## SEWAGE DISPOSAL SYSTEM

SUBDIVISION Roman Ridge Estates LOT 1 ROAD 2167 McKendree Road

REPAIR - PURPOSE - FAILING DRYWELL.

SEWAGE DISPOSAL SYSTEM

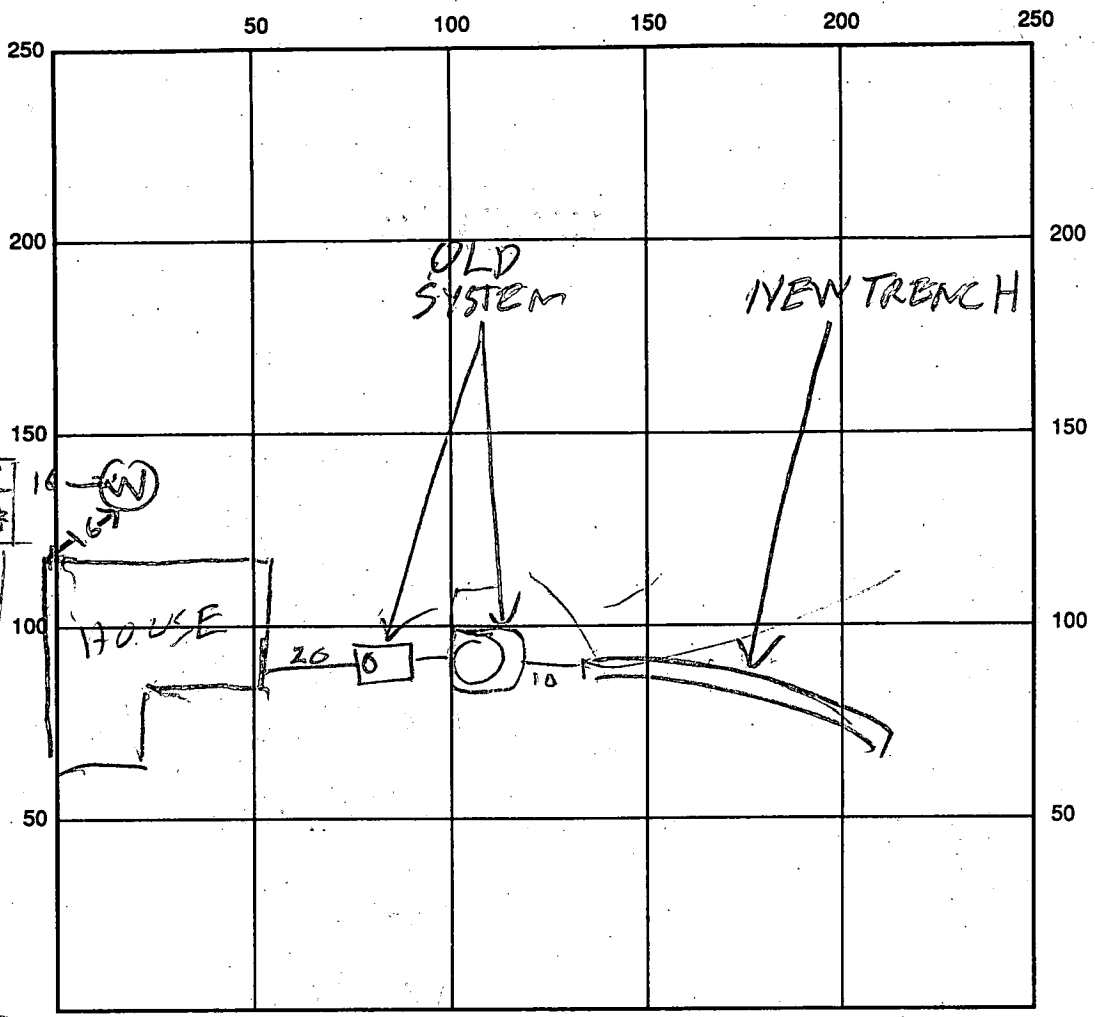
Call for inspection when ground is opened so sanitarian can recommend repair. 9/17/92  
9/16/92 TRENCH OFF OLD DRY WELL 12 FT DEEP 2 FT WIDE  
WITH 6 FT OF STONE 375 SQ FT SIDEWALL AREA 63 FT LONG  
PLACE THE TRENCH OFF THE OLD DRY WELL & RUN  
AWAY FROM THE HOUSE BH

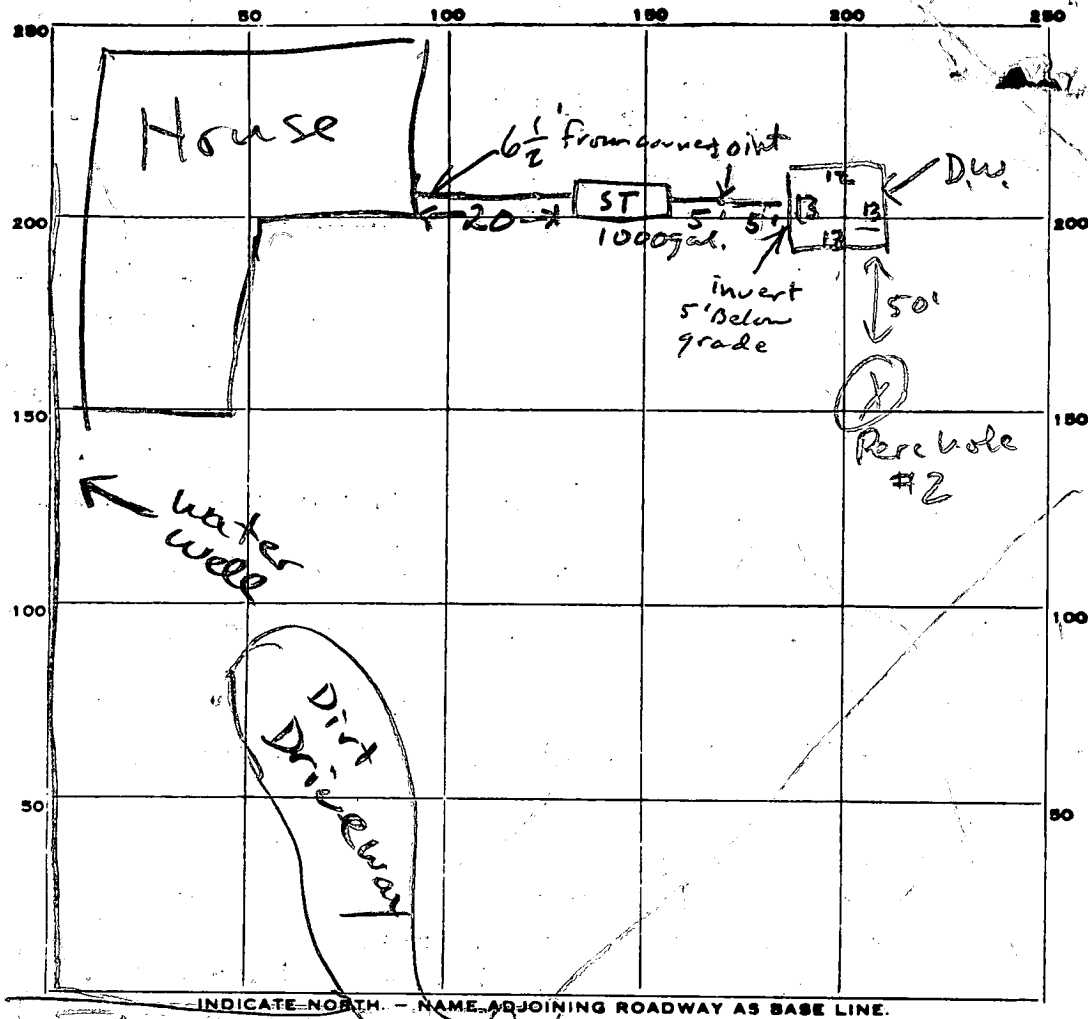
*5/29/78 T.S.O.: Dry well short on space footage.  
Require 20' trench off DW. after 5' earth buffer.  
Maximum trench depth to be 14' feet. Absorbent area begins  
at 4' (7' stone) see Attached Worksheet*

REMARKS Raise lid of D.W. to 2 ft below grade. Call office for other options. (add second lid? add two feet gravel + distribution pipe?)

5/31/78: see Attached Worksheet

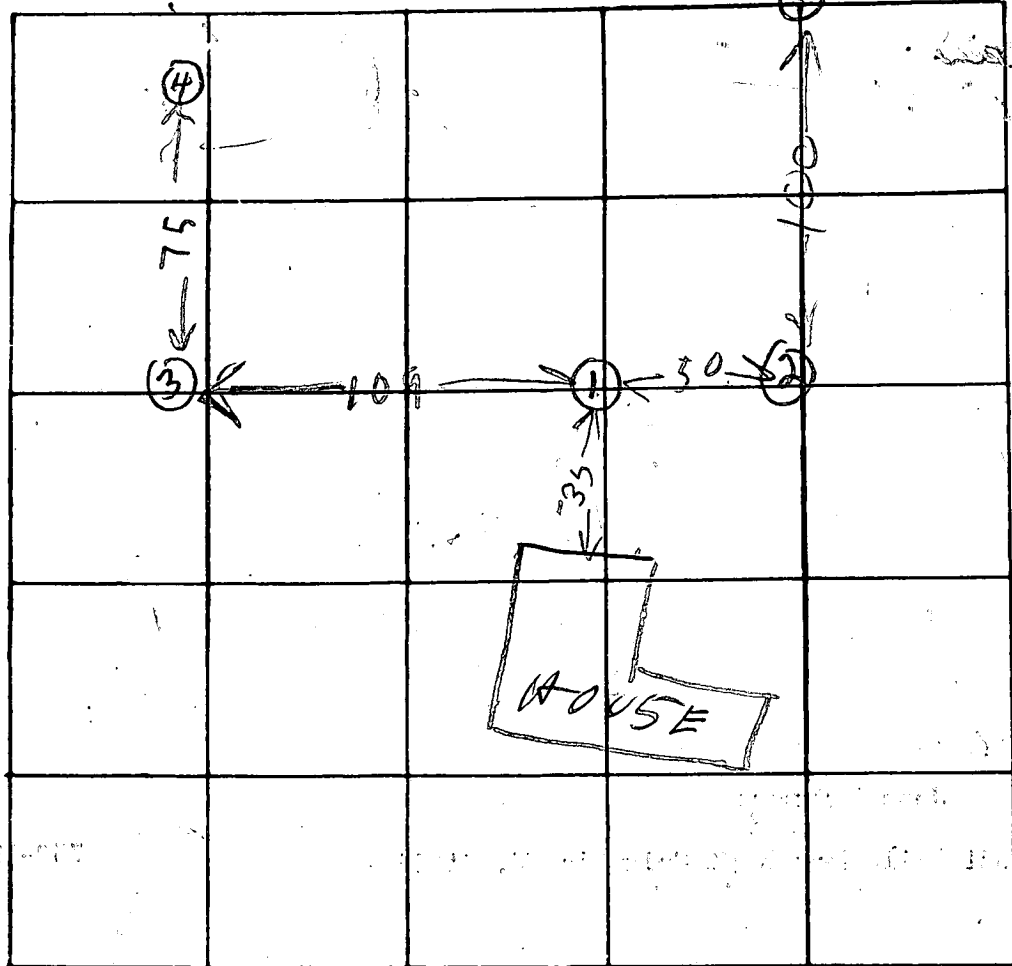
REASONS FOR REJECTION OR HOLDING 4/27/77 - PERC O.K. BUT

CERTIFIED PERC HOLES LOCATION PLAN NEEDED R.R.

REMARKS Century hole location & Dry Well Site  
 TYPE OF SOIL DW in Hole ① Inlet 2 ft below grade

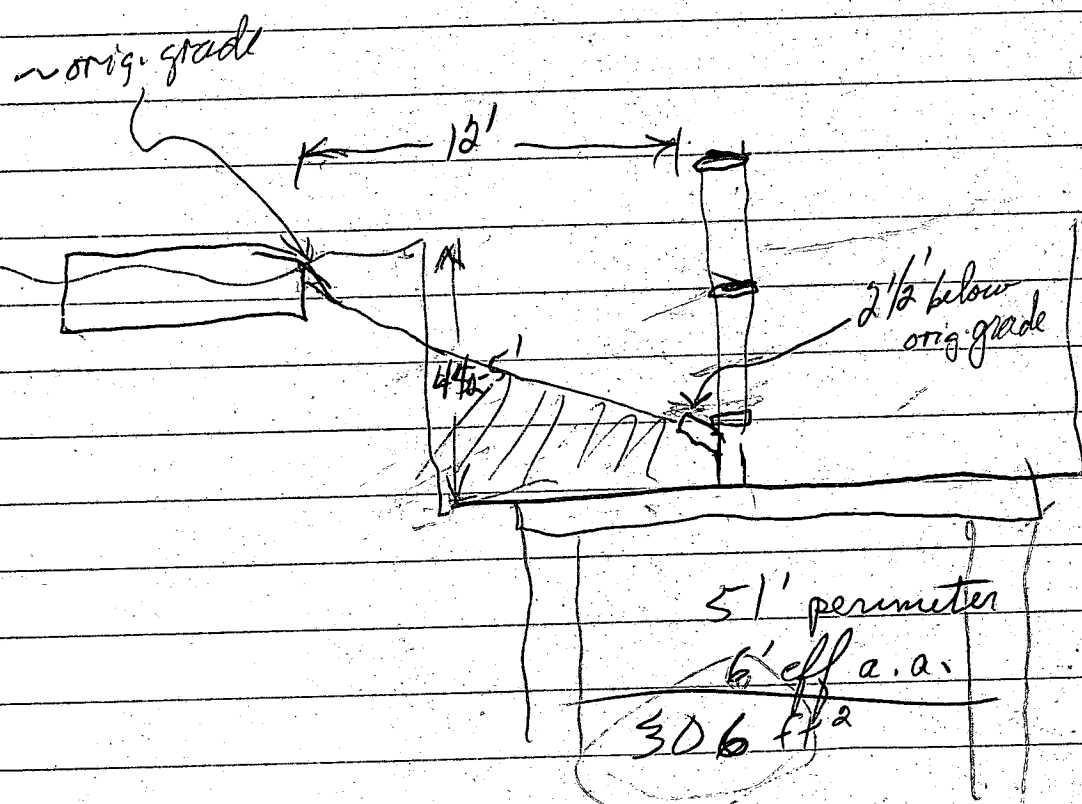
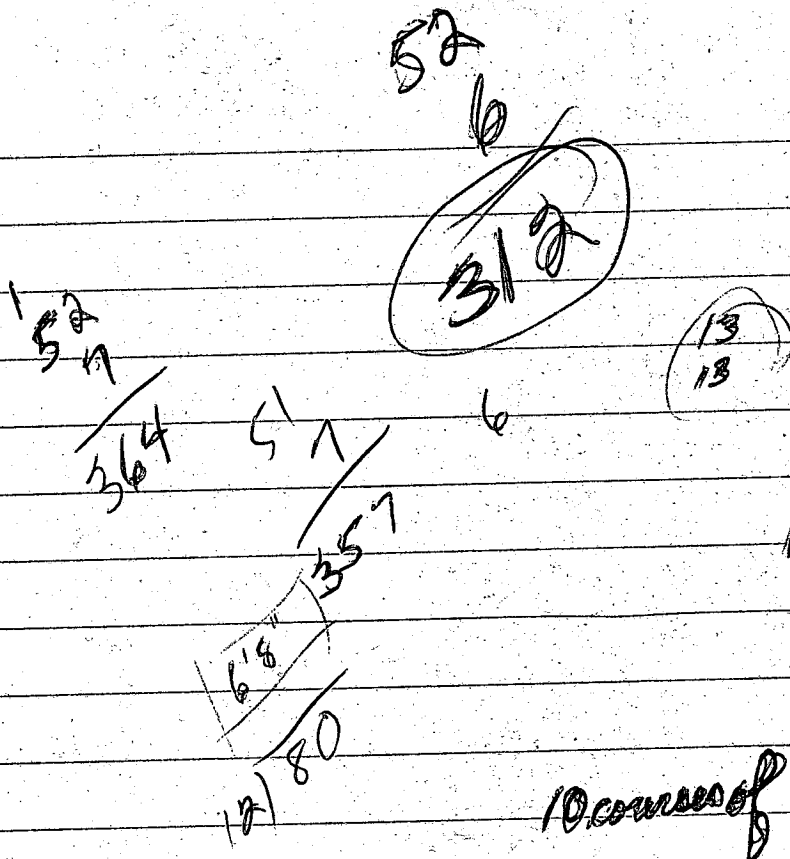
*Dry well to have 125 sq. ft. effective absorbent sidewall area per bedroom below first 5 1/2' of original soil and maximum depth 12'. Inlet can come in at 4'. Location 130' in from left property line and 286' towards front of lot from left rear corner pt. when facing lot from McKendree Road (see hole 1+2)*
